CLAREMONT BUSINESS PARK 2 FILING NO. 2

CONSTRUCTION PLANS

FEBRUARY 2023

EL PASO COUNTY FILE NO. VR233

CONSTRUCTION STANDARD DETAILS

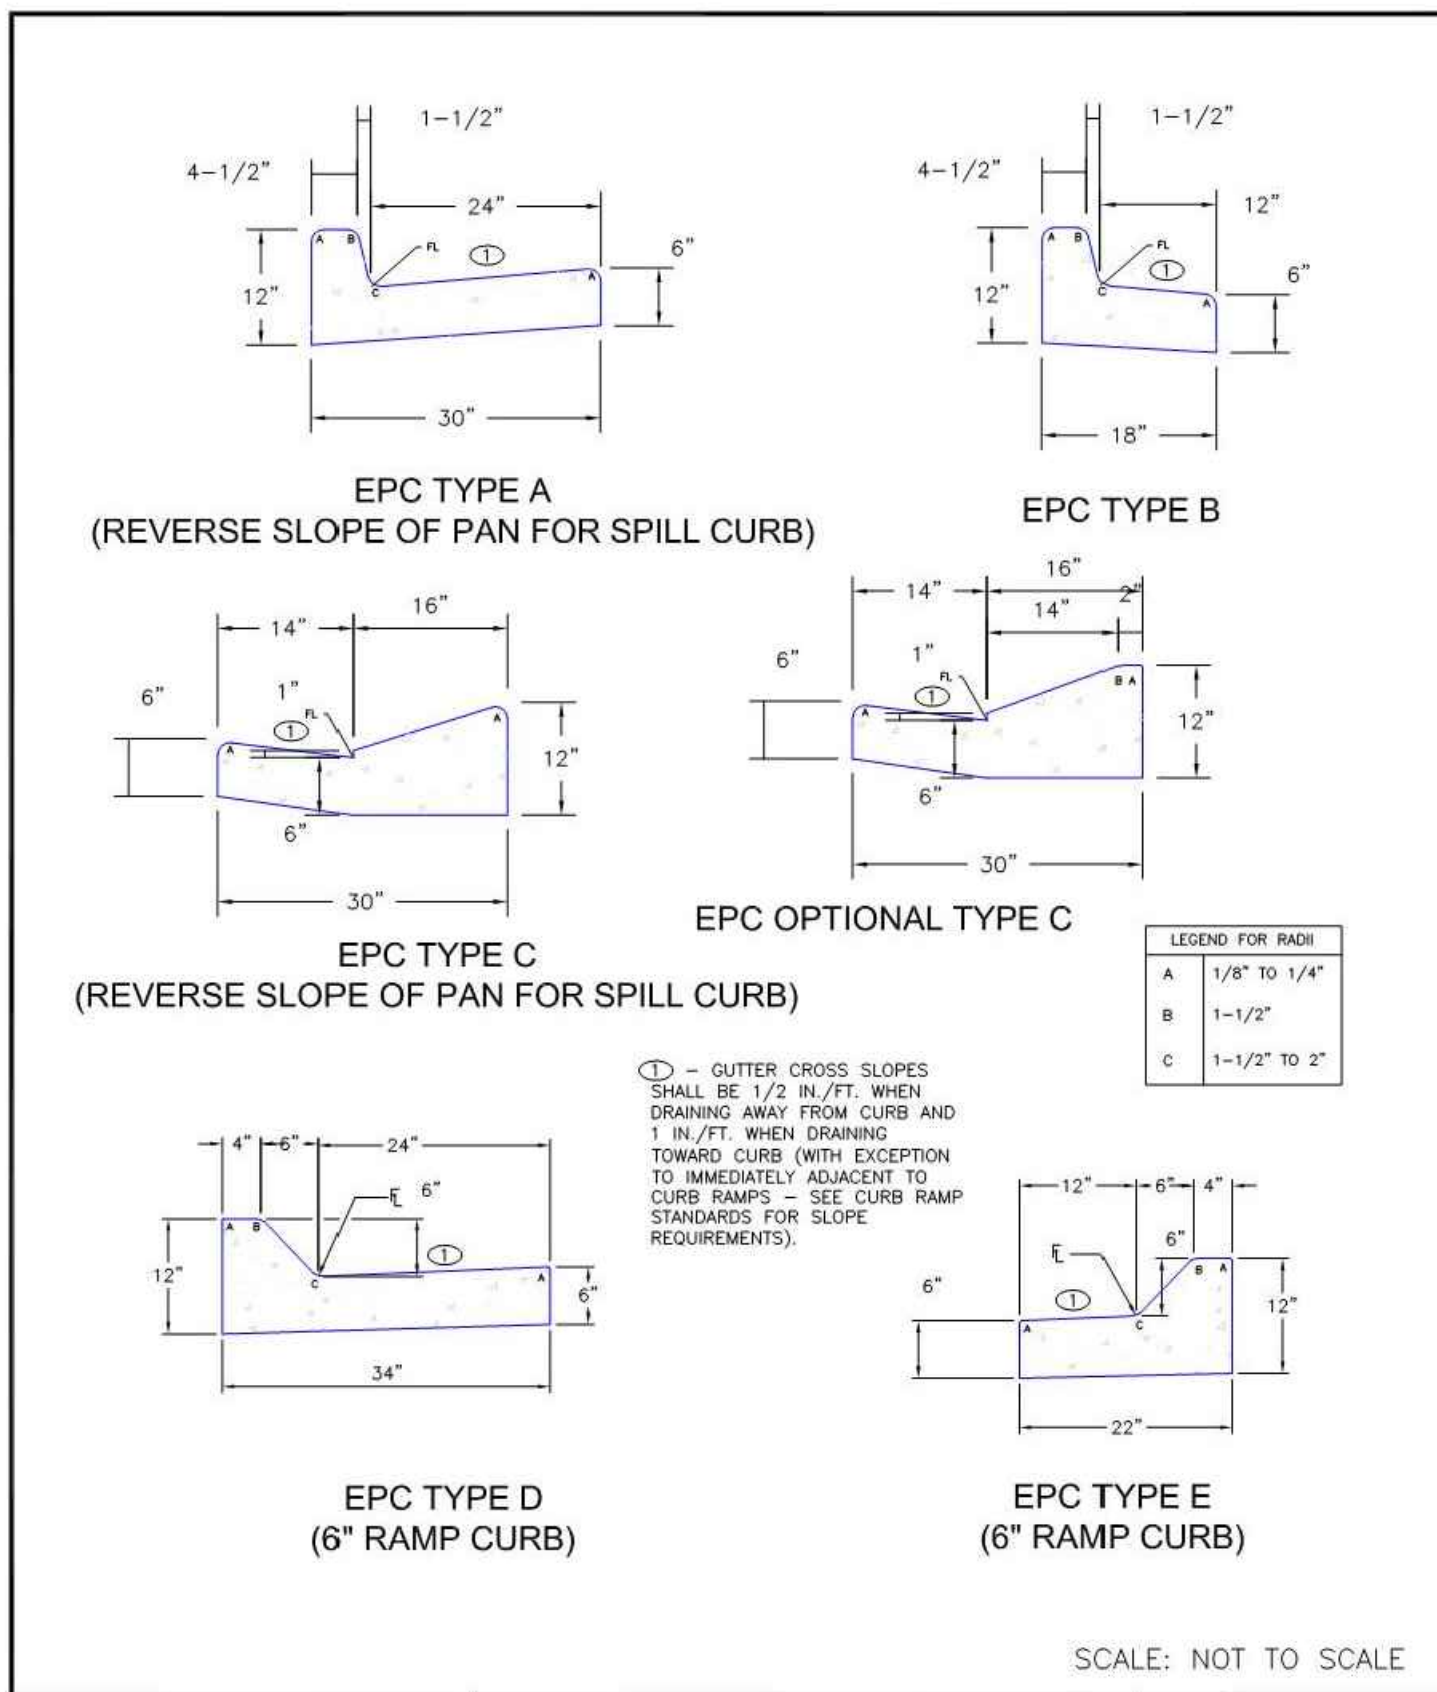
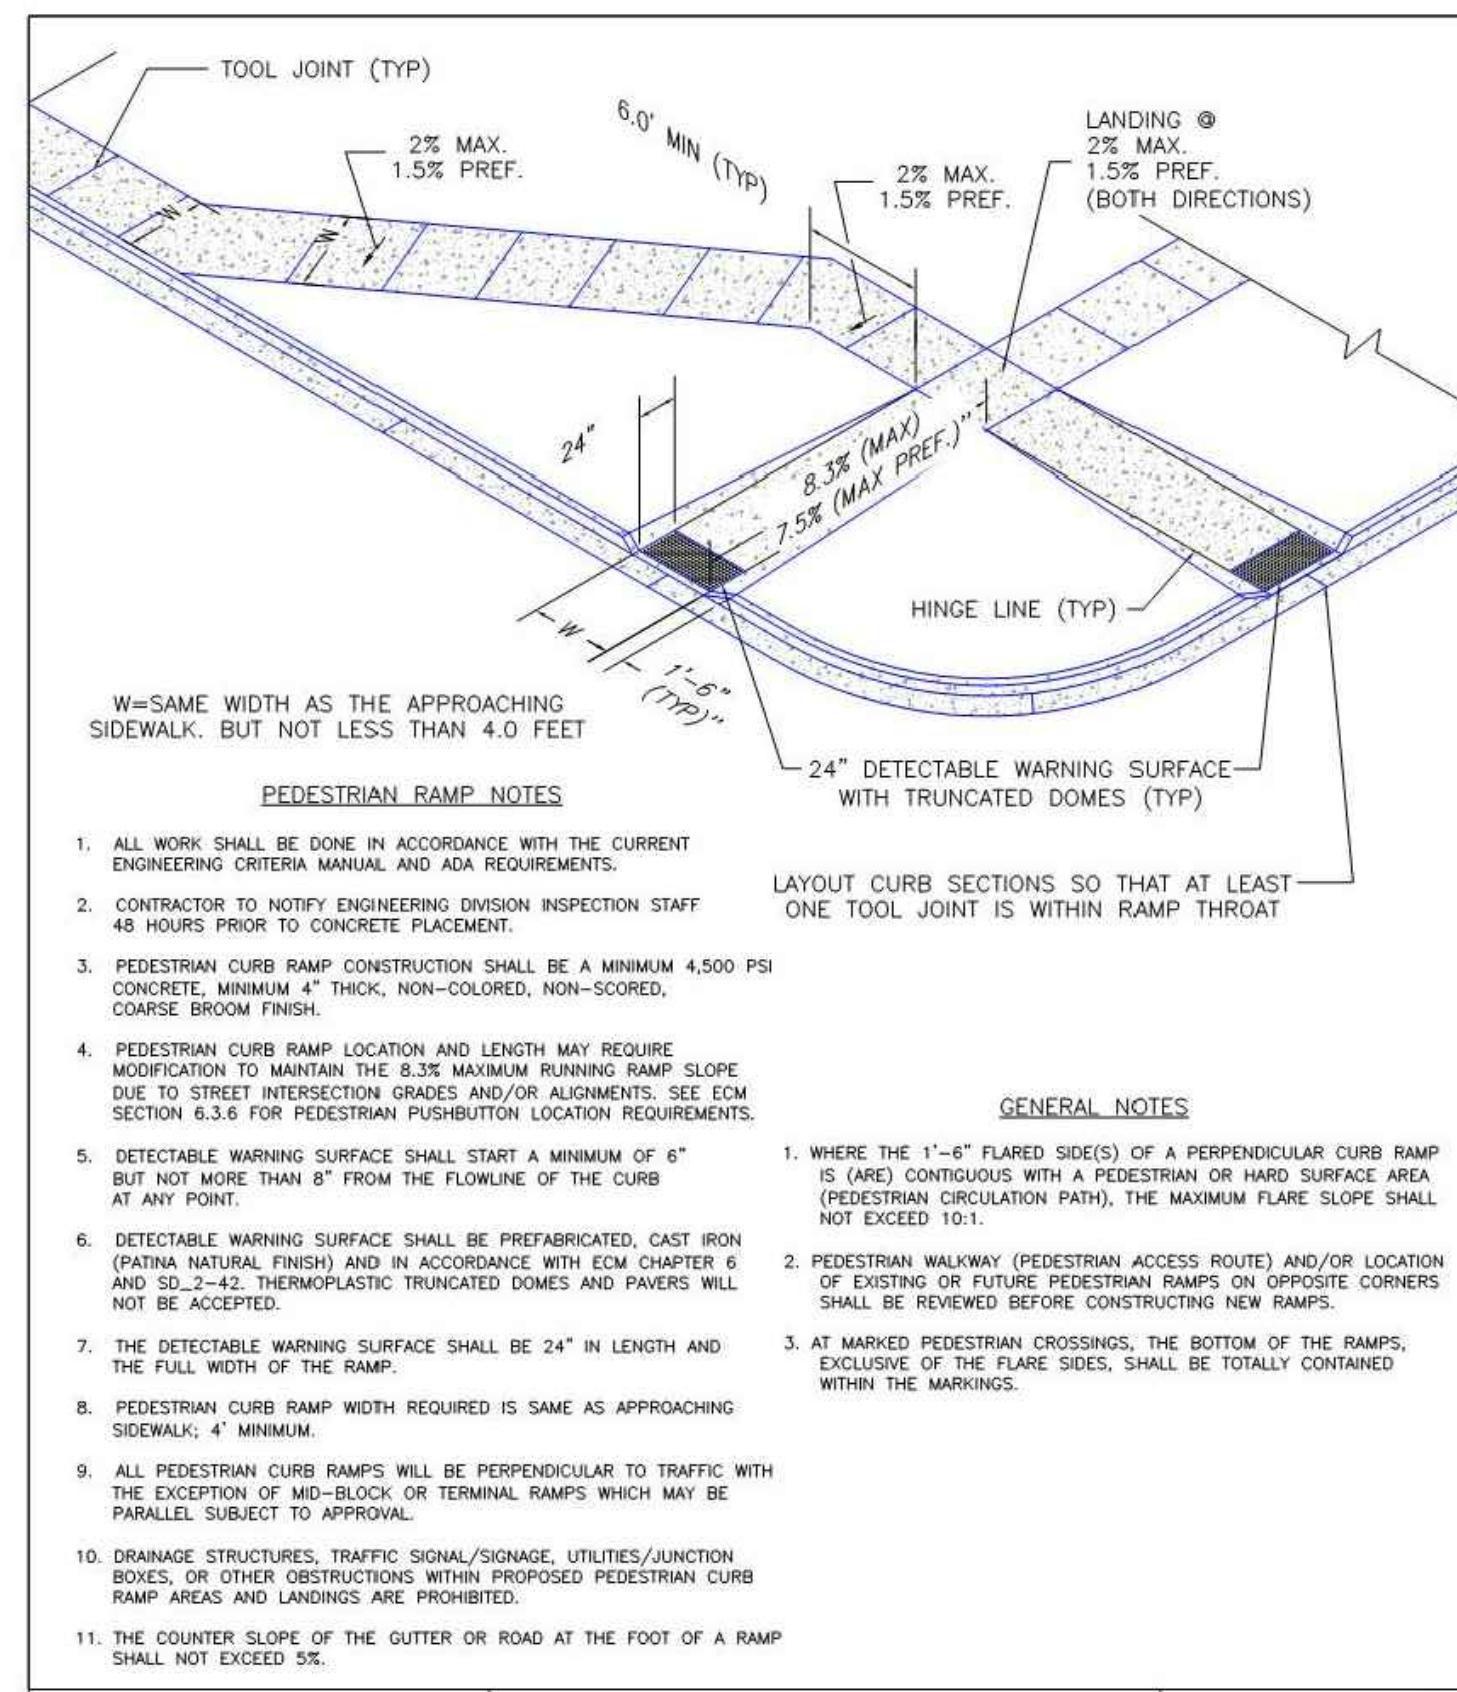
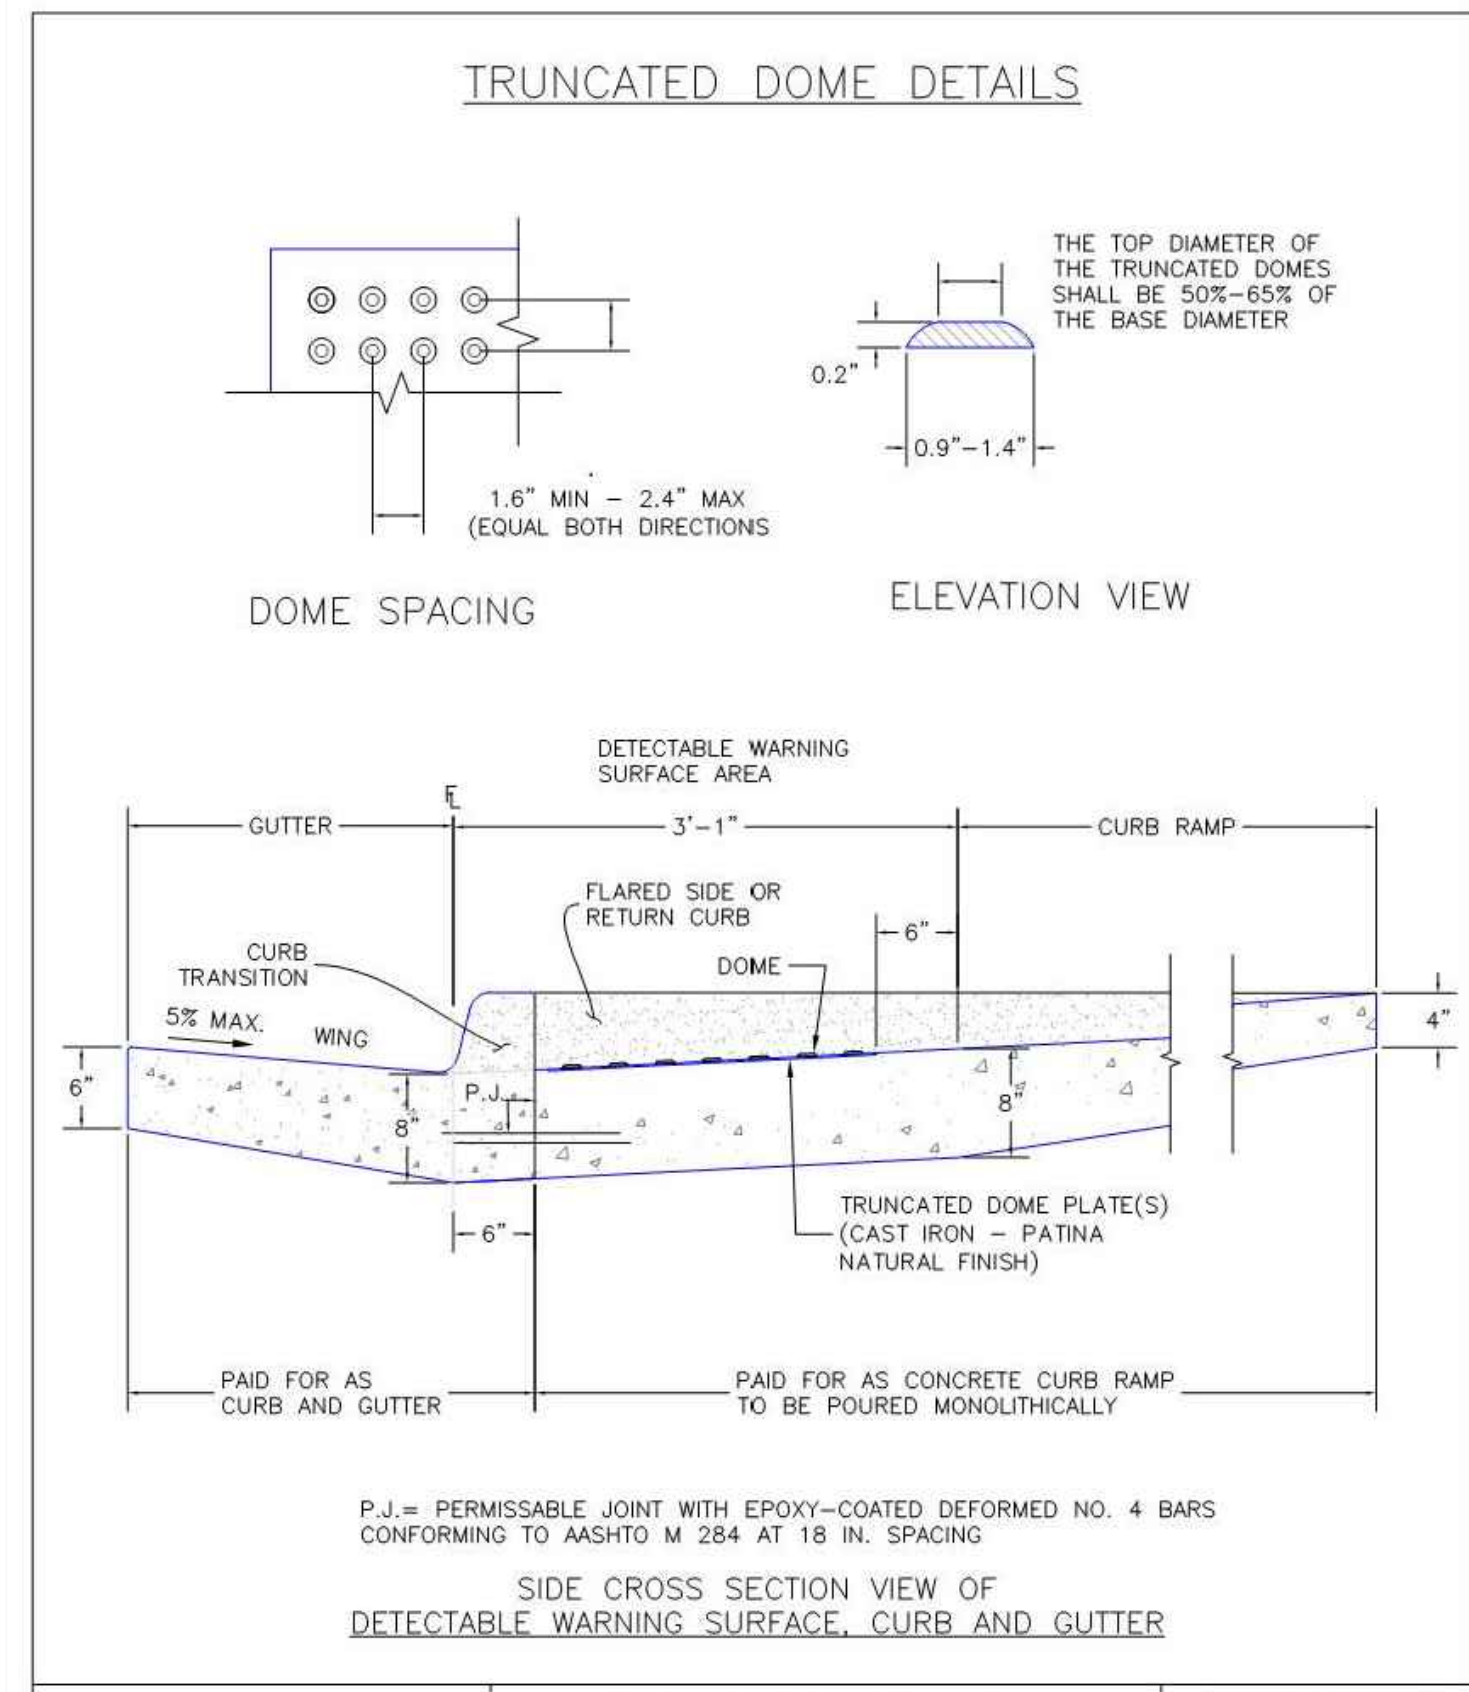
Please add El Paso County Standard Detail SD_2-24 Driveway Detail with Attached Sidewalk
